Access Compliance Report Public Rights-of-Way (Curb Ramps)

Main Street: N/A Cross Street: ESPERANZA_RD Location: NE

ADA ID: RPAT210923141840 Ramp Type: Type 7 - Directional 2 Initial Pass/Fail: Fail Overall Compliance: No Severity Score: 45

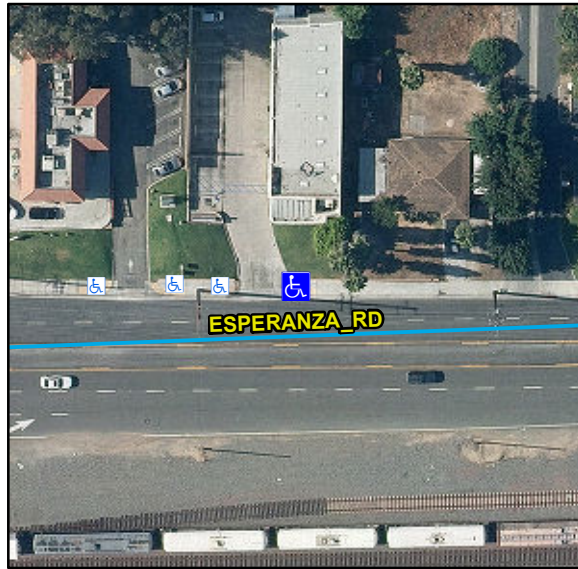
R304.2.2, R304.5.3, STD 1115

Compliance	Description	Data	Compliance	Description	Data
N/A	Ramp Length (in)	76	N/A	Flare Type LT	
Yes	Ramp Width (in)	79			N/A
No	Ramp Run Slope (%)	10.1	N/A	Flare Slope LT (%)	N/A
No	Ramp Cross Slope (%)	10.7	N/A	Flare Traversable LT	N/A
N/A	Grade Break	N/A	N/A	Flare Type RT	
N/A	Grade Break Slope (%)	N/A			N/A
N/A	Grade Break Cross Slope (%)	N/A	N/A	Flare Slope RT (%)	N/A
	Addl Para Ramp Left?	N/A	N/A	Flare Traversable RT	N/A
	Addl Para Ramp Right?	N/A	N/A	DWS Provided	N/A
N/A	Landing Present	N/A	N/A	DWS Contrast	N/A
N/A	Landing Length (in)	N/A	N/A	DWS Length (in)	N/A
N/A	Landing Width (in)	N/A	N/A	DWS Full Width	N/A
N/A	Landing Run Slope (%)	N/A		DWS Offset Type	N/A
N/A	Landing Cross Slope (%)	N/A	N/A	DWS Left Offset (in)	N/A
N/A	Landing Movement Obstructed?	N/A	N/A	DWS Right Offset (in)	N/A
	Landing Movement Type	N/A			
N/A	Landing Shared	N/A			
N/A	Marked Crosswalk 1	No	N/A	Clear Space	N/A
	Crossing 1 Direction	W	N/A	Clear Space To Crosswalk (in)	N/A

Marked Crosswalk 1 Width (in)	N/A			
N/A	Ramp Inside Crosswalk 1	N/A			
	Crossing 1 Slope (%)	3.3			
	Crossing 1 Cross Slope (%)	3			
N/A	Gutter Ponding	N/A	N/A	Curb Slope	7.9
Yes	Gutter Lip Height (in)	0		Road Run Slope (%)	1.1
N/A	Gutter Run Slope (%)	N/A		Road Cross Slope (%)	1.6
N/A	Gutter Cross Slope (%)	N/A		Parallel Ramp Side	Left
Yes	Overall Surface Condition	Acceptable	Yes	Perp Joint Present	Yes
	Cross Gutter Present?	Yes		Spandrel Present?	Yes
	Replace Cross Gutter?	No		Replace Spandrel?	No

Remove & Replace Entire Ramp.
